UNITED STATES PATENT AND TRADEMARK OFFICE

APPLICATION NO.	FILING DATE	FIRST NAMED INVENTOR	ATTORNEY DOCKET NO.	CONFIRMATION NO.
10/727,046	12/04/2003	Toru Nakao	Q78736	4823

Office Action Summary

DETAILED ACTION

FIG. 7

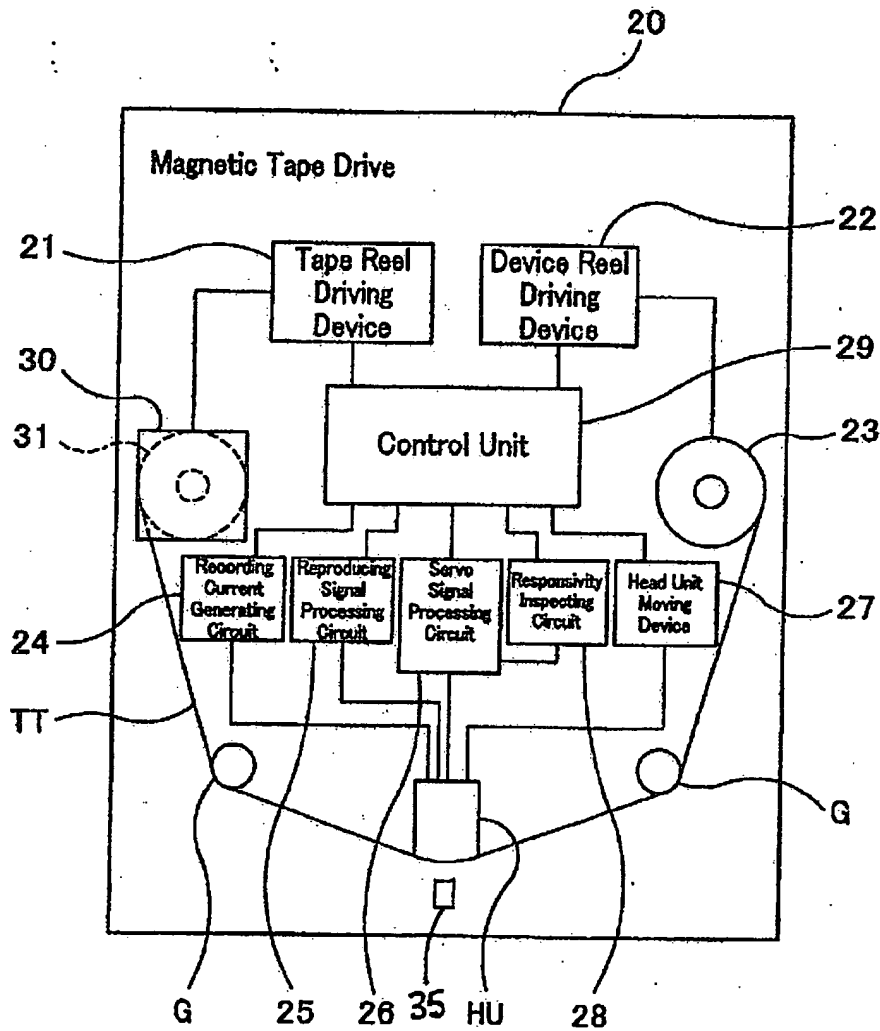
1. The drawings are objected to under 37 CFR 1.83(a). The drawings must show every feature of the invention specified in the claims. Therefore, as stated in claim 10, "an inspection apparatus head unit moving device" and its details as claimed must be shown or the feature(s) canceled from the claim(s). No new matter should be entered.

2. It is suggested that the phrase "an inspection apparatus" be changed to "a magnetic tape drive". This title would conform to Fig 7 that contains a "head unit moving

device". It is also suggested in the first sentence of the claim that a reference is made to "the method of claim 1". Lastly, it is suggested that the term "comprising" be used in place of the phrase "which is equipped with".
